**PM5946**

# **S/UNI-LITE OPTICAL REFERENCE DESIGN (SORD) ERRATA**

**ISSUE 3: MARCH 1998**

This document is the errata notice for Issue 2 of the S/UNI-LITE OPTICAL REFERENCE DESIGN (SORD) PM5946 (document number PMC-940106P3).

Fig:1 Recommended Loop Filter Circuit

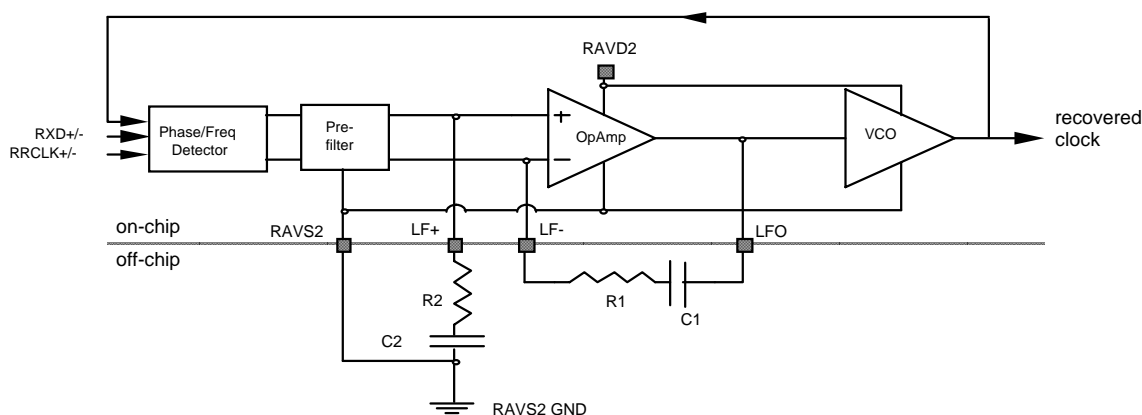
Since the S/UNI-LITE is a terminating device, it is not a requirement in most applications to meet jitter transfer mask. ~~In this case the transistor can be removed and the loop filter components in Table 2 below can be used.~~ The loop filter values were chosen to achieve maximum jitter tolerance performance in the LAN.

Line Rate (Mbit/s)	R1 (Ohm)	R2 (Ohm)	C20, C21 min (μF)	Transfer Function BW (kHz)
155.52	200	412	0.15	450
51.84	200	412	0.47	150
25.92	200	412	1.0	75
12.96	200	412	2.2	37.5

Figure 2: PAL functional diagram

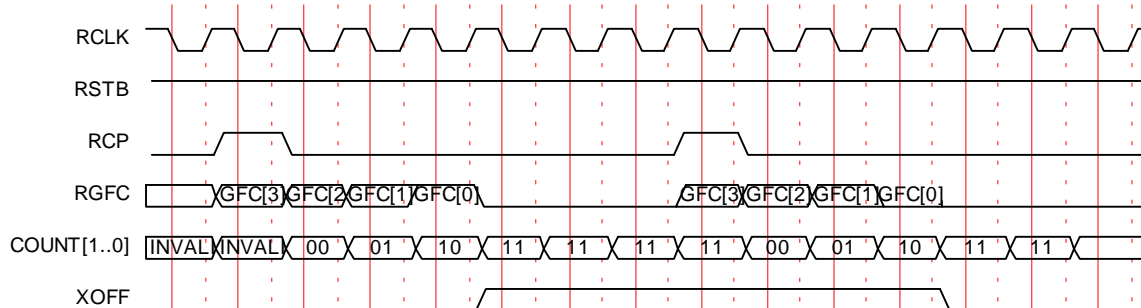
Once the XOFF is asserted, it is held in the same state until the next GFC[0] is received. The following functional diagram indicates how the PAL would generate XOFF based on GFC[0]:

(SCHEMATIC PAGE 2 OF)

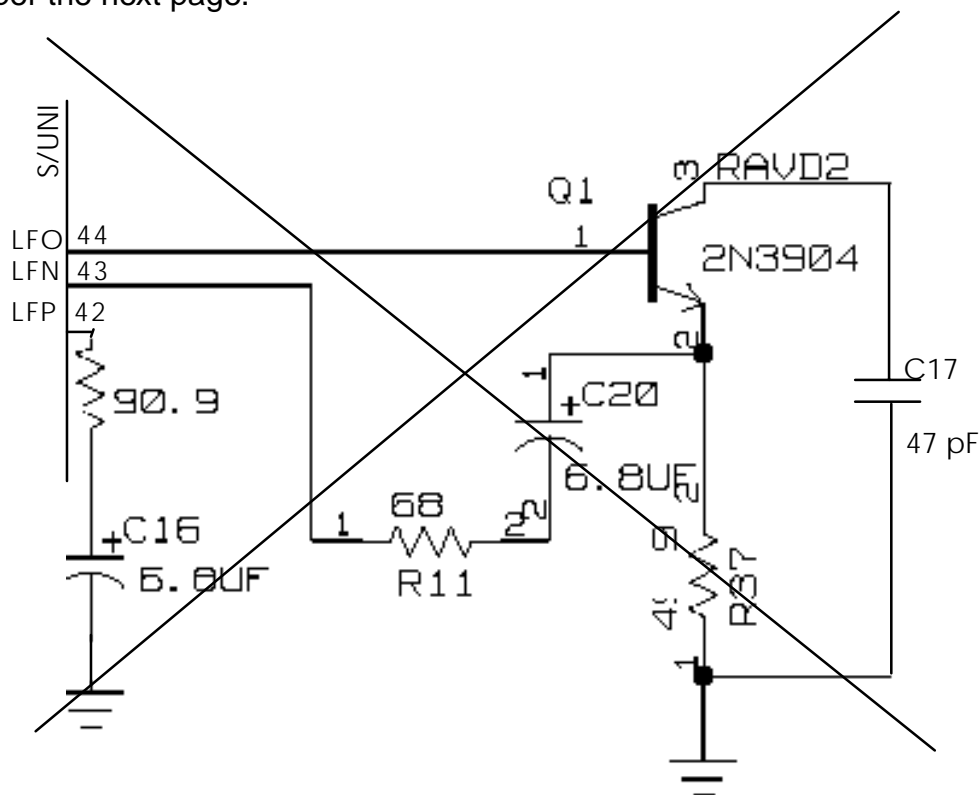
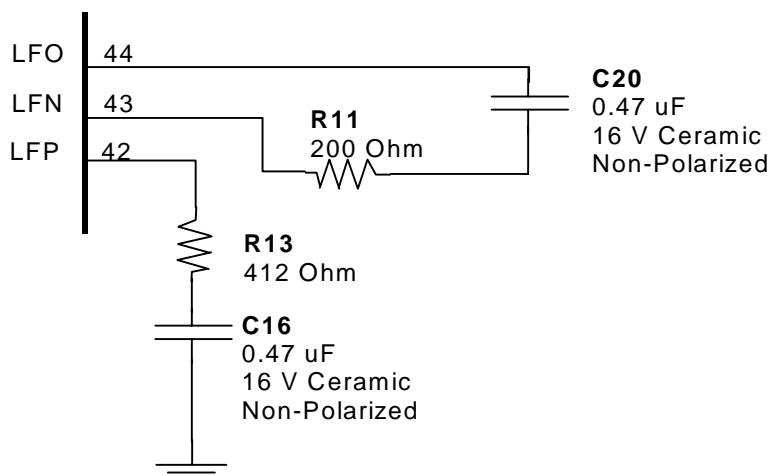
Essentially, the BJT transistor and 68 ohms, 90.9 ohms and 4.7uF is not recommended for the loop filter. Only the ASYM design as per page 112 of Issue 6 of the PM5346 Data Book is recommended.

The following is the original page out of Appendix E in the SORD document. Notice it includes the transistor Q1 and 6.8  $\mu$ F capacitors which are changed as per the next page.

- 1) Delete C17, 47 pF cap
  - 2) Delete Q1, 2N3904
  - 3) Delete R37, 49.9 ohm resistor
  - 4) Change C16 6.8 uF polarized cap to a 0.47 uF 16 V ceramic non-polarized
  - 5) Change C20 6.8 uF polarized cap to a 0.47 uF 16 V ceramic non-polarized
  - 6) Change R13 from 90.9 ohms to 412 ohms
  - 7) Change R11 from 68 ohms to 200 ohms
- 4) Note: R11 and R13 can be 1/10 Watt SMT devices

Fig.2: S/UNI-LITE' ANALOG POWER SUPPLY FILTERING

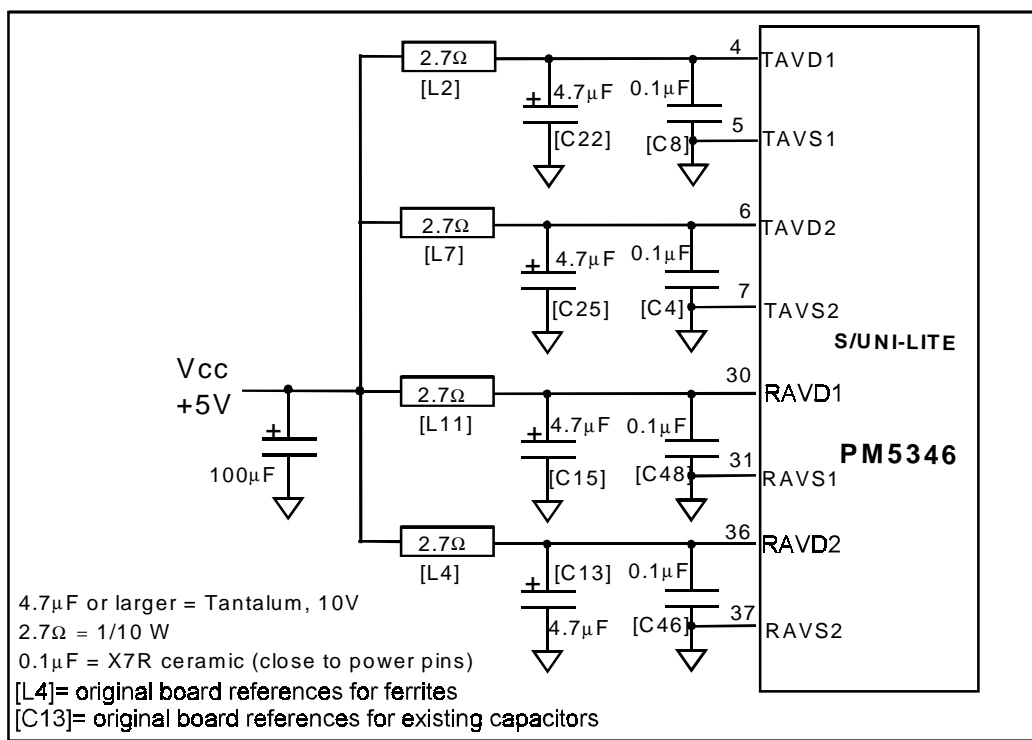
We have found that it may be desirable to include a low frequency power supply filter circuit, especially if powered by a switching power supply. This circuit is recommended to reduce noise seen by the S/UNI-LITE four analog power pins TAVD1, TAVD2, RAVD1, RAVD2. All the other power pins must be de-coupled as recommended in the SORD Board reference design schematic, as per document PMC-950112 (R2). This modification will improve jitter performance.

The original schematic on page 3 of 4 must be modified as follows:

- 1) Replace ferrites L2, L7, L11 and L4 with a 2.7 ohm , 1/10W, 5% resistor.
- 2) Replace capacitors C22, C25, C13, and C11 with a 4.7 $\mu$ F or larger, 10V Tantalum
- 3) Replace capacitors C8, C4, C48 and C45 with a 0.1 $\mu$ F Ceramic X7R.
- 4) The new 0.01  $\mu$ F caps should be closest to the IC power pins.

Fig.2: OSCILLATOR POWER SUPPLY FILTERING

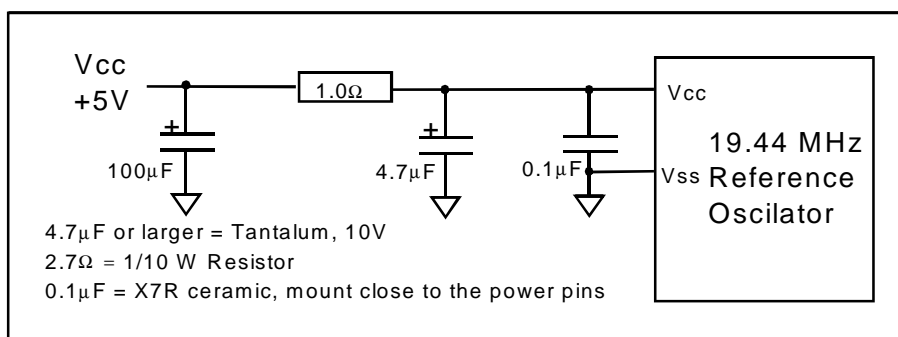
Oscillators are susceptible to noise on their power supply pins. The following change is recommended especially if powered by a switching power supply. The original schematic on page 1 of 4 in Appendix E of the PMC-950112 (R2) must be modified as follows:

- 1) Replace L8 with a  $1.0\ \Omega$  resistor.
- 2) Replace  $0.01\ \mu\text{F}$  capacitor C32 with a  $4.7\ \mu\text{F}$  or larger, 10V Tantalum.
- 3) Replace  $0.001\ \mu\text{F}$  capacitor, C30 with a  $0.1\ \mu\text{F}$  X7R Ceramic.
- 4) There should also be a  $100\ \mu\text{F}$  bulk capacitor near by on the +5 Volt power supply

Make sure the  $0.1\ \mu\text{F}$  capacitors are close to the IC pins. The  $1.0\ \Omega$  resistor can be a low power 1/10 watt.
